CITY OF ALBUQUERQUE

PLANNING DEPARTMENT – Development Review Services

RE: Valle Prado Units 1 & 2- (File: C09D011)
Justification for Removal of 250' of Storm Drain from Infrastructure List for
Valle Prado Unit 1 (DRB # 1004404, CPN # 740581)
Supplemental Calculations, (InRoads dated 11/11/2014)
Revised Inlet and Storm Drain Network Map, 11-12-2014

Re: Valle Prado Units 1 and 2, DRB 1004606, CPN#740581 (C09/D011)

VALLE PRADO
FULLY DEVELOPED BASIN MAP

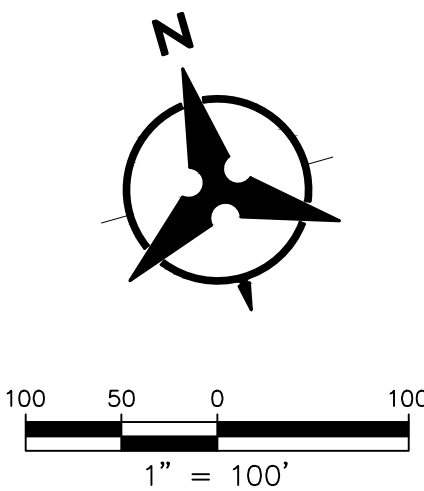
Per the approved Valle Prado Units 1 and 2 (VP DR) drainage report, runoff from Basin E3 (Tract 6) is conveyed via internal residential streets to the storm drain network in Valle Prado Units 1 and 2, which discharges to Pond E. Basin E3 is contained within portions of VP DR Future Basins 1, 2 and 3. Woodmont Avenue has capacity to convey runoff from Basin E4 (13.1 cfs) without inlets within Basin E4. The VP DR shows inlets just west of the Nightshine Street entrance to Valle Prado Unit 1 that intercepts 10.4 cfs of flow, with a bypass of 3.4 cfs. The inlet location is just downstream of Basin E4. The only flow that would be in the storm drain west of Nightshine Street would be the 3.4 cfs outflow from Pond B.
